# SERVICE BULLETIN

from: TRIO-KENWOOD COMMUNICATIONS, INC.

#851R

SUBJECT: TS-830S Noise Blanker Optional Improvements

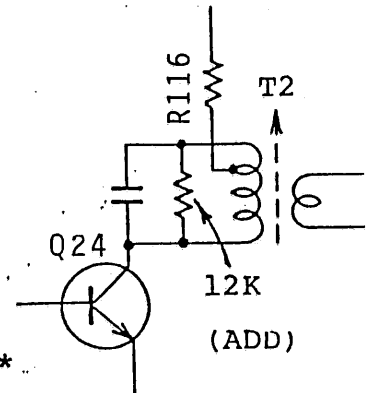
At the Noise Blanker level control VR8, change R19 from 22Ω to 15Ω (RD14BB2E150J)\*

AF UNIT X49-1140-00

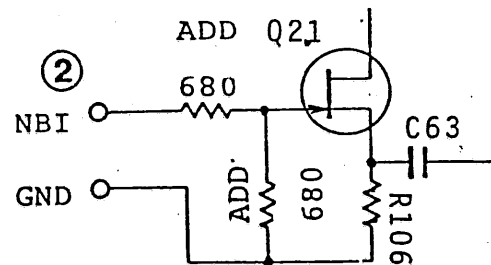
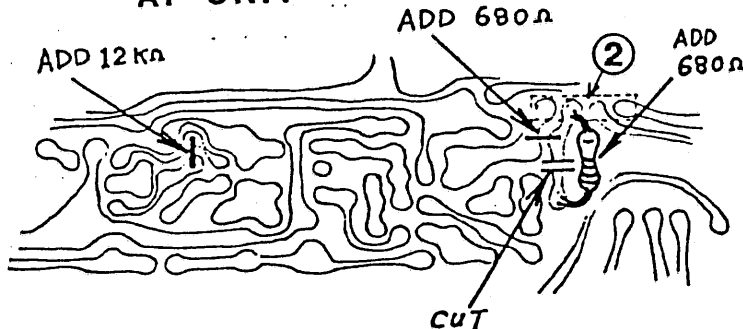
On the AF AVR unit X49-1140-00 (vicinity of Q20) change:  
D22 from an MV-13 to an MV-203 (V11-3379-16)\*  
R96 from 2.2kΩ to 820Ω (RD14CB2E821J)\*

(vicinity of Q24)

R112 from 47KΩ to 56KΩ (RD14CB2E563J)\*

Across T2, (Fig. 1) add a 12KΩ (RD14CB2E123J)\*

At Q21 (Fig. 2,3) add 2 pcs. 680Ω (RD14CB2E681J)\*
